January 26, 1994

Joseph M. Farley Nuclear Plant
Request for Additional Information Regarding
Southern Nuclear Operating Company Responses To
Issues Related to FNP Electrical Distribution System Functional Inspection

Request for Additional Information Regarding Southern Nuclear Operating Company Responses To Issues Related to FNP Electrical Distribution System Functional Inspection

CURVE NO. 772411

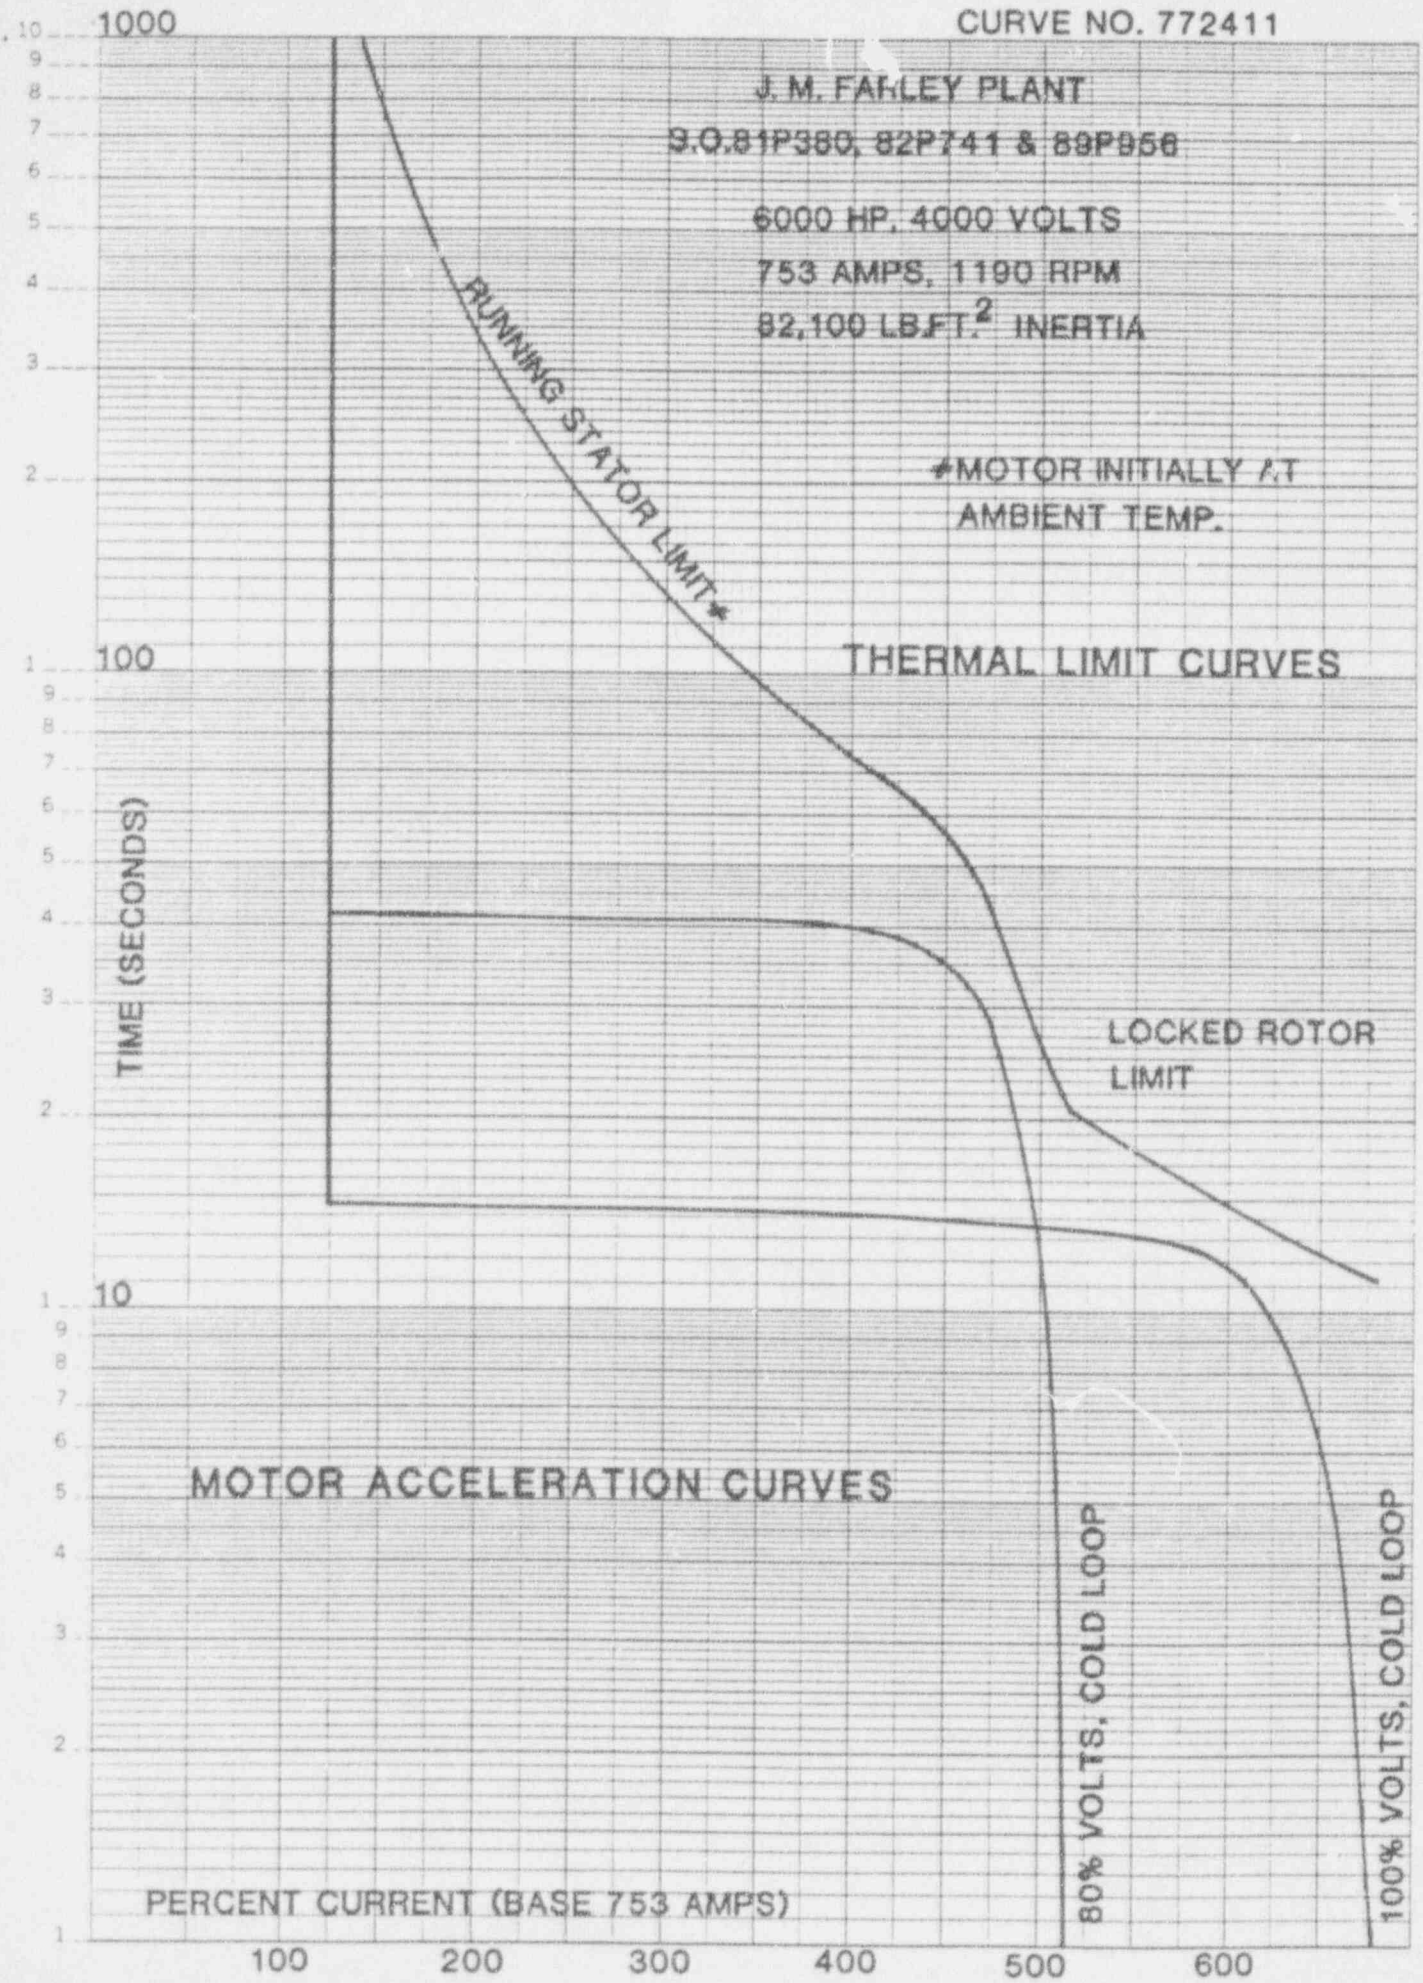
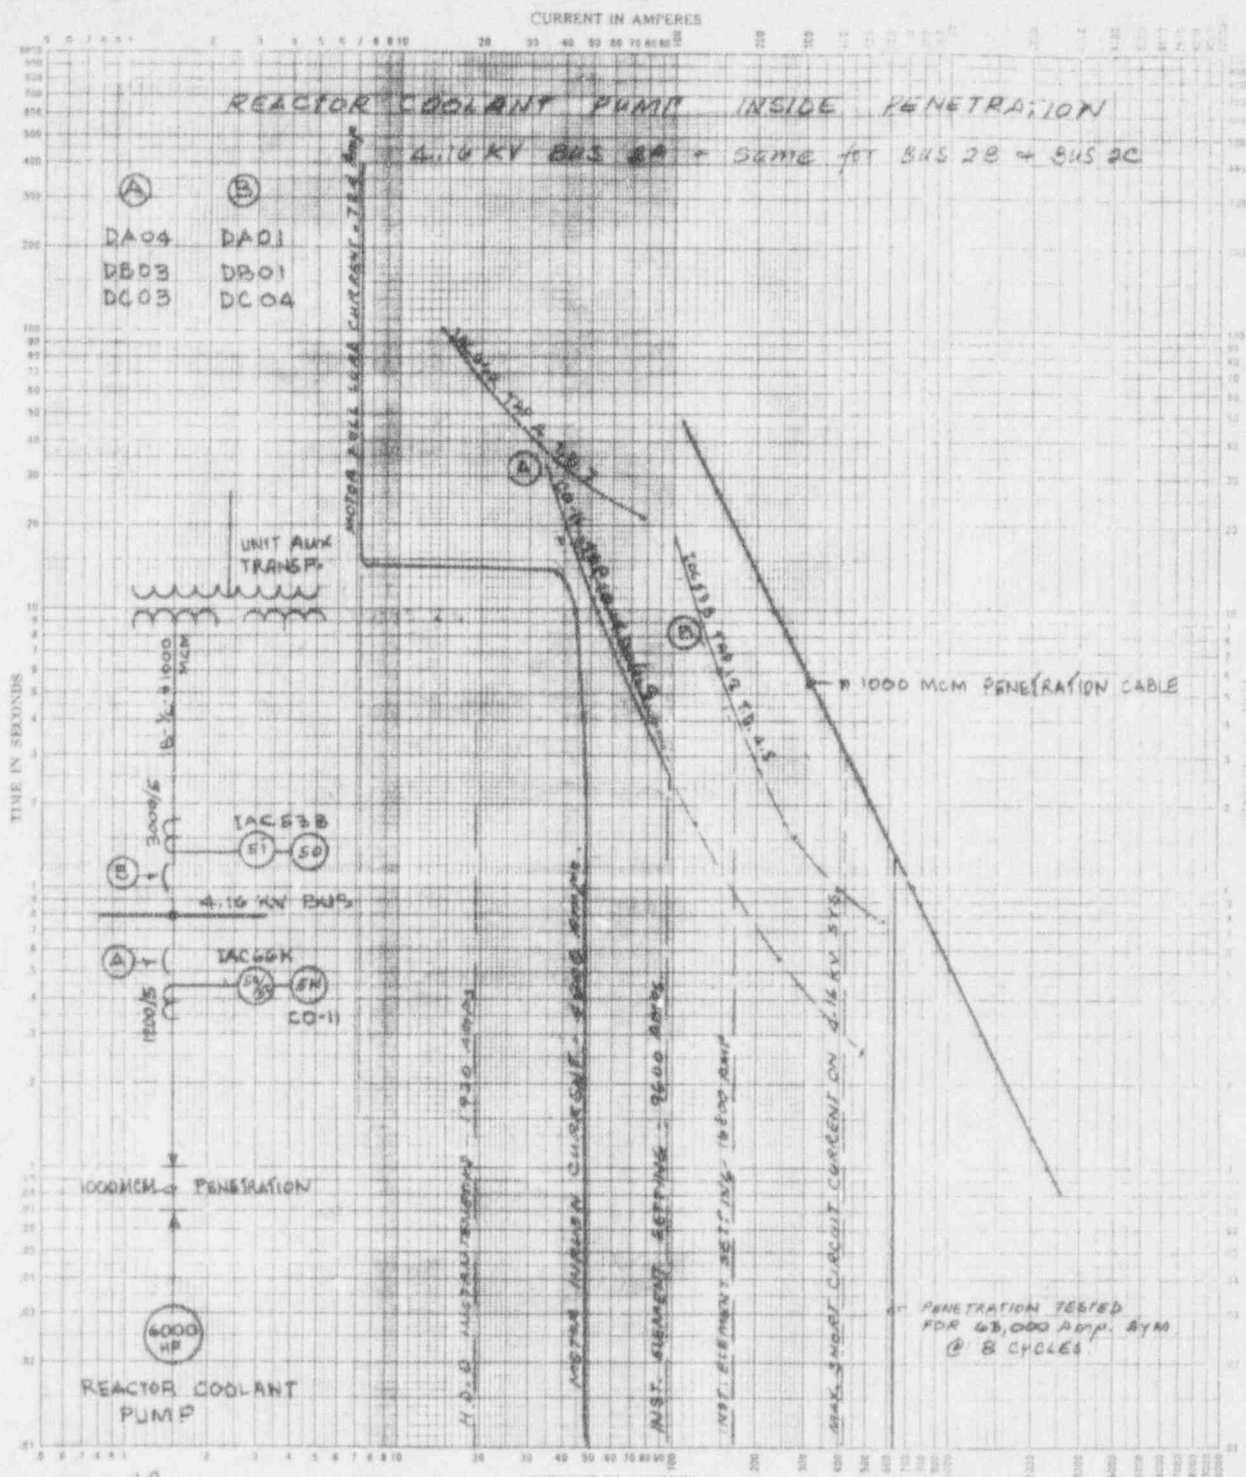
Provide time-current characteristic curves for equipment items associated with the reactor coolant pump motors. The response should include: (1) inrush current (I_s) curves with 80 percent and 100 percent bus voltage available, (2) both relay curves used for the RCP motor protection (IAC66K and CO11), (3) thermal limit curves for RCP motor stator and rotor windings, (4) RCP motor bus upstream main breaker thermal limit curves, (5) RCP motor

- RCP Motor Acceleration and Thermal Limit Curve
- Protective Relaying Curves
- RCP Main Breaker and RCP Motor Cable Thermal Limit Curves
- Containment Penetration Thermal Limit Curve

As discussed in the SNC response to EDSFI issues dated November 5, 1993, the FNP design provides motor winding temperature alarms to ensure protection during motor running (i.e., normal operation below 2000 amps). During motor starting, protection is provided by the combination of IAC66K relay and the CO-11 relay. This combination provides complete protection from approaching the motor thermal limit from 2000 amps to approximately 3700 amps. Above 3700 amps it is possible to exceed the RCP motor thermal limit for a few seconds prior to protective relay actuation. Although this relaying scheme does not afford complete protection from exceeding the thermal limit, this scheme was determined to be optimal, in terms of maximizing motor protection while limiting nuisance trips, during plant design and startup. Experience has confirmed these settings to be adequate.

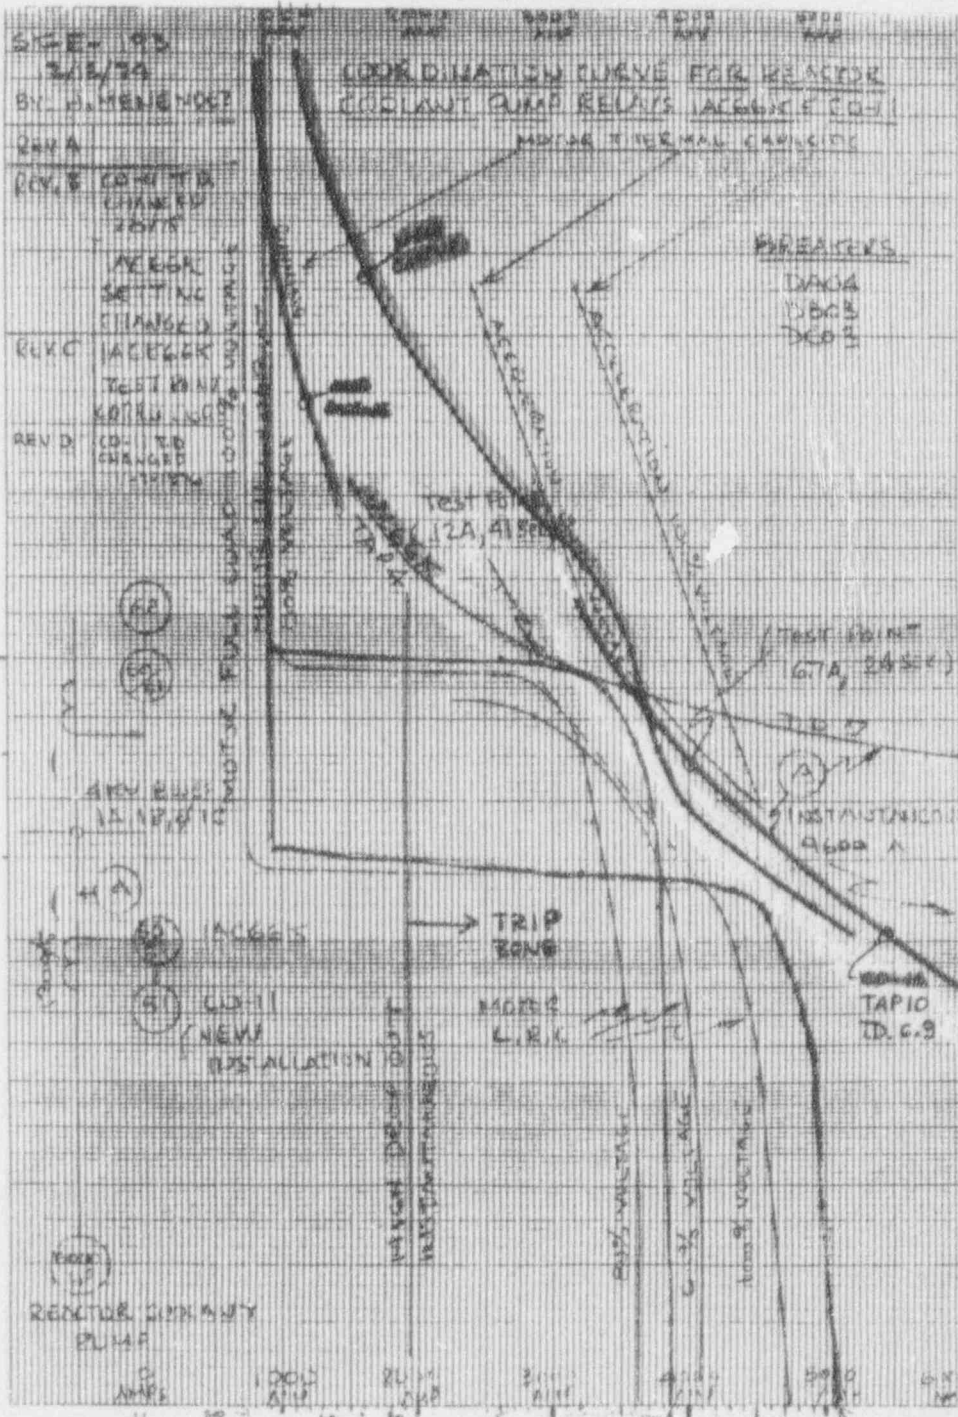
cable thermal limit curves, (6) containment penetration thermal limit curves, and (7) fuse thermal limit curves, if fuses are connected in series between the RCP motor feeder breaker and the RCP motor. In addition, provide relay trip setpoints for protective relays IAC66K and CO11.
